MINOR PROJECT REFINEMENT REQUEST FORM

Request Number: 02

PG&E Humboldt Bay-Humboldt #1 60kV
Minor Project Refinement No. 2

Client/Project 185705825
 PG&E Humboldt Bay-Humboldt #1 60kV
 Minor Project Refinement No. 2

Figure 1 - Project Overview

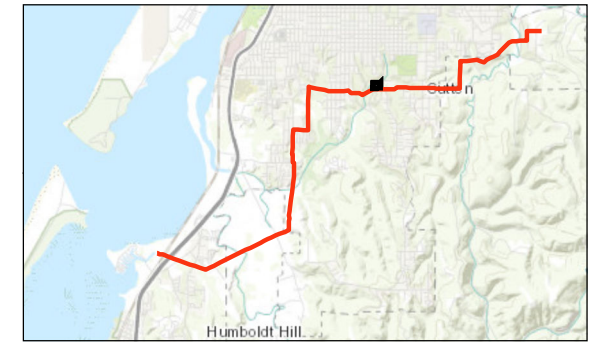
The proposed landing zone is located within fenced pastureland surrounded by sloping redwood forest and rural residential development. As shown in the attached MPR Figure 1, approximately half of the proposed landing zone is assumed 3-parameter wetlands associated with the Martin Slough wetland complex. These wetlands are seasonal with dry soils and vegetation that has already gone to seed. The project would avoid impacts to seasonal wetlands by confining equipment operations and material storage to upland areas and to the recently graded area within the proposed LZ. Due to the size of the helicopter, take-offs and landings would need to occur as far from the landowner residences as possible to avoid damaging the structure. This could require the helicopter to land in southeast corner of the LZ potentially within the seasonal wetland boundary. Because the wetland is dry, no impacts to the seasonal wetland are anticipated from helicopter take-offs and landings. Helicopter refueling would occur offsite at other approved LZ's or at commercial refueling facility.

Perennial wetlands occur outside of the proposed boundary adjacent to the seasonal wetlands along the southern edge of the proposed LZ (see attached photo in Biological Resources Memo). The southern boundary of the LZ would be fenced to prevent accidental encroachment into the perennial wetland, and sediment control BMPs would be installed along the southern boundary of the LZ in accordance with the project SWPPP. Therefore, activities at the landing zone would not impact the adjacent perennially saturated wetland. In accordance with APM BIO-7 and APM BIO-9, work will not occur within the perennially saturated wetland and per APM BIO-2 refueling will occur offsite or in a designated location at least 100 feet from the perennially saturated wetland. A 100-foot buffer from the perennially saturated wetland is shown in Figure 1.
